Lowering Radiant Temperatures

The Glitch

Overview: A project requires both medium and low temperature radiant floor panels. The installer proposes the following system design.

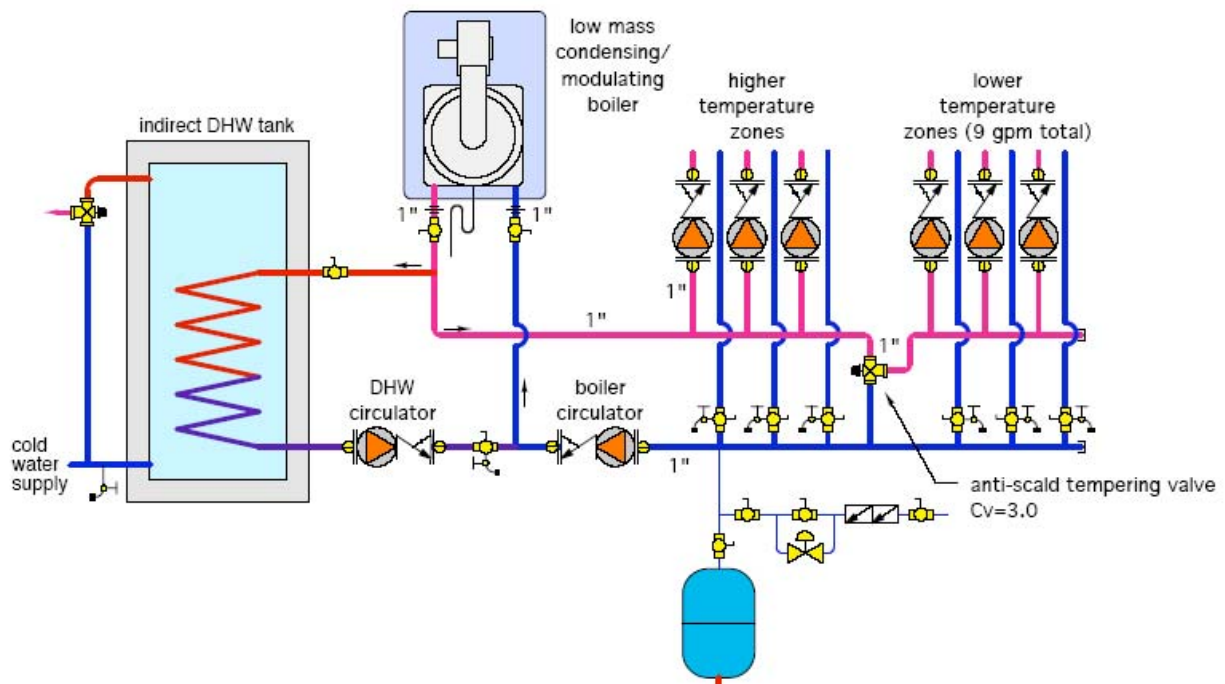
Since the mod/con boiler already has an internal outdoor reset controller, he decides to use a standard 1-inch tempering valve to lower the water supply temperature to the lower temperature zones. He also decides that since the boiler supply and return connections are 1 inch, he can pipe the entire system with 1-inch tubing.

Exercise: Can you spot at least four design details that are going to create problems?

The header piping in the original design is the same size (1 inch) as the piping to individual zone circulators. This will likely create a high pressure drop when all zone circulators are operating. The pipe size of the distribution headers in the fix drawing has

been increased to minimize head loss and thus minimize hydraulic interference between zones.

The boiler circulator needs to be hydraulically separated from the circulators in the distribution system. This has been corrected using the closely spaced tees.

The 1-inch tempering valve with $C_v=3.0$ has been replaced with a properly size 3-way rotary mixing valve with much higher C_v ($C_v=10$) and hence lower pressure drop. Although a motorized actuator is shown on the mixing valve, it may not be required. A manually set (non-thermostatic / non-motorized) 3-way valve can provide proportional reset control to the lower temperature zones when the hot water supplied to the valve is reset by the boiler. The motorized actuator is recommended in situation where the lower temperature zones will have frequent setback or temperature adjustment. A check valve is installed in the hot water pipe to the 3-way valve to prevent flow reversal when other zones are operating.

A microbubble air separator has also been added, such that flow from the boiler passes through it during both space heating and DHW operating modes.
